DATE: September 4, 2020
TO: Prospective Respondents
FROM: Amy Lucey, Contracts Administrator
SUBJECT: Addendum #2 to Invitation for Bids # 35868, Crane Creek M-1 Canal Restoration

As a result of inquiries, the following clarifications/changes are provided for your information. Please make all appropriate changes to your bid documents. Note: changes are reflected with original language shown with strike-through and new language is underlined.

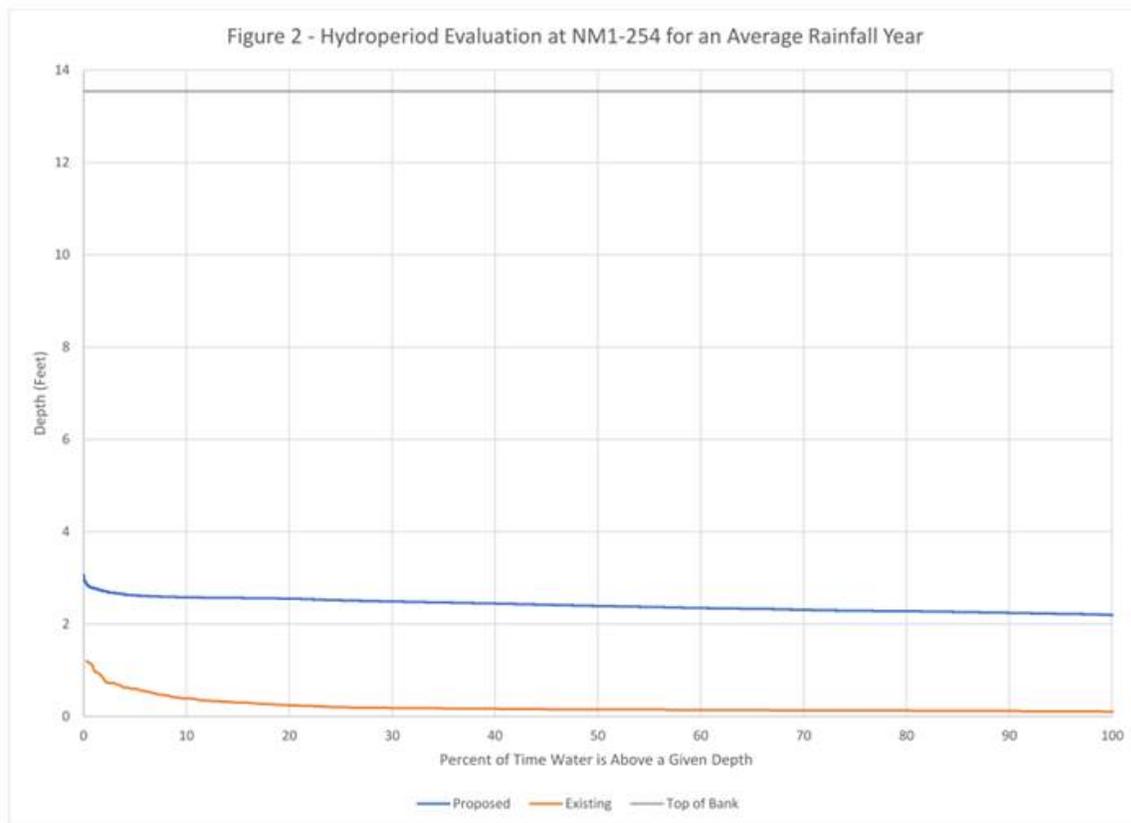
Q27. What is the observed elevation changes throughout the year of the canal?

A27. **We do not have observed elevation changes through the year available to us. The data we have available is the following graph showing modeled water depths over an average year at the weir site under existing conditions and with the proposed weir and pump operating. This does not necessarily represent highs and lows in the canal.**

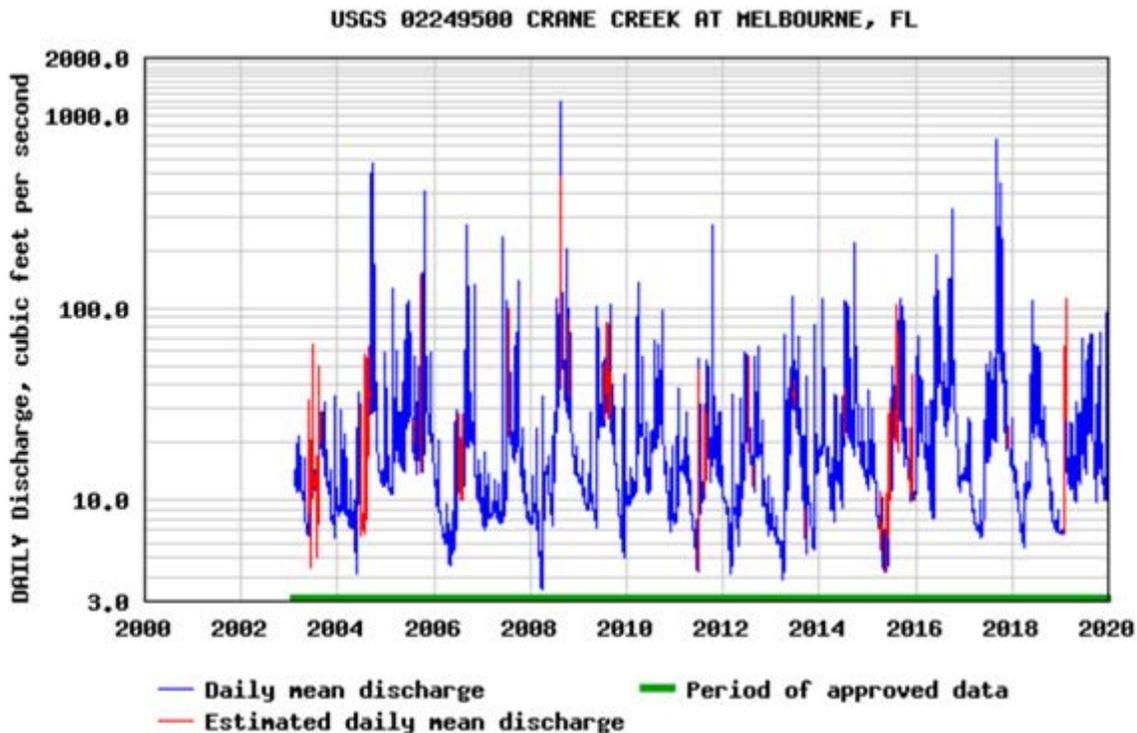
Q28. What is the approximate flow rates throughout the year of the canal?

A28. **The following shows flows recorded by the USGS over the last 16 years at the stream gauge at New Haven Road, downstream of the weir site.**

The peak recorded flow at this USGS gauge was 1,700 cfs,

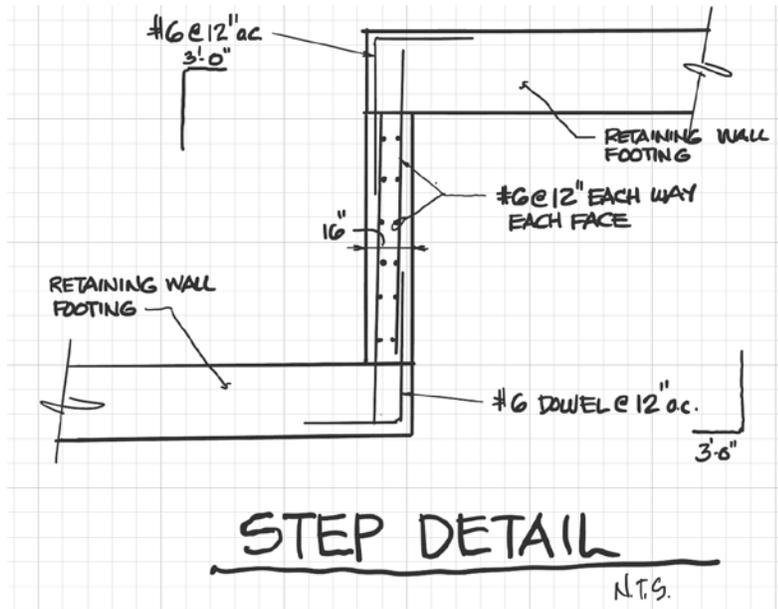
- A46: No**
- Q47: There is a significant change in elevations for the foundations for the weir wall footings – see Details 1 through 5 on Sheet S5-2. Please provide a step detail for the weir wall footings.

- A47: The step in the retaining wall footings will include a 16 inch thick wall constructed perpendicular to the retaining walls. The wall will extend the full width of the lower retaining wall footing and go from the top of the lower footing to the underside of the upper footing. It will be reinforced with #6 @ 12" each way each face, with the vertical bars on the**

outside faces. #6 dowels on one side, top and bottom, will lap with the vertical bars within the wall and hook 3'-0" at the far side of the footings (top of the upper footing, and bottom of the lower footing). See sketch below.
